CONSERVATION TEAM CONSULTATION APPLICATION RESPONSE

APPLICATION REF:	26/00612/FP & 26/00613/LBC
CASE OFFICER:	VW
APPLICATION SITE:	The Biggin, Queen Street, Hitchin, Hertfordshire SG5 1AB
DESCRIPTION OF WORKS:	Installation of perimeter railing, gate and wall following removal of existing fence. Installation of free-standing Air Source Heat Pump and associated enclosure, new bin and cycle store together with hard and soft landscaping works including low-level lighting. Internal and external alterations including replacement windows and installation of secondary glazing.

Pocket to provide means of temporary propping for repairs.

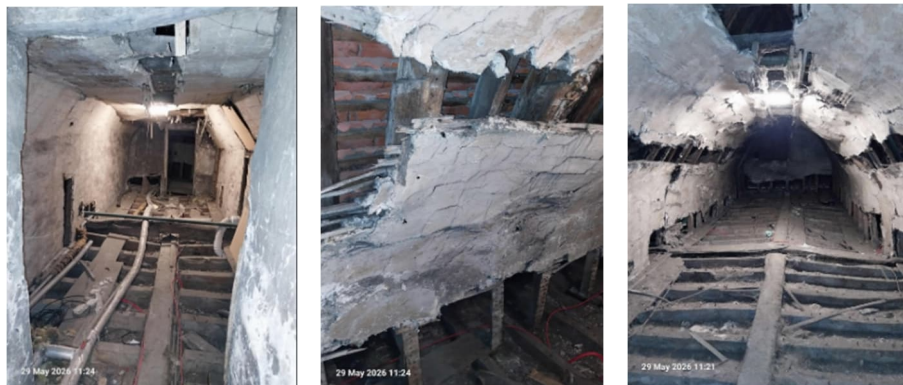
3.66. One interesting feature was a raking cut to form a pocket in the side of the central post above the cloister. This was almost certainly introduced to provide a 'jacking' point, such that a robust and

slightly overlong timber strut could be located into the pocket at an angle to the ground. As the base of the strut was driven sideways, towards the pocket, the structure above would be lifted, taking load off the ground floor elements for repair: an early form of Acrow Prop.

This point of interest should be retained (images below left and centre) and is in the vicinity of the lean-to shelter in the image at page 10 of the SofSig (below right).

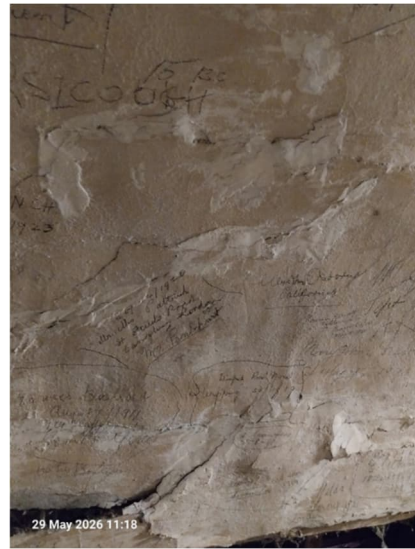
The significance of the smoke blackening is noted, and I am interested in 3.58 to 3.62. As stated, there are significant areas of signed/graffiti plaster and in the photo below left there are dates from 1899, 1900, 1907, 1921 etc. whilst in the image below right places referred to include California, Wapping, Bermondsey(?) etc. This clearly indicates significant use of the attic floor but there is no reference to the 'attic' or indeed the 'roof space', in the SofSig.

The significance of these inscriptions is not fully understood but a level of recording is advised in case of further loss considering the need to undertake duct work and install walkways in the loft. This has the potential to be important archive information.
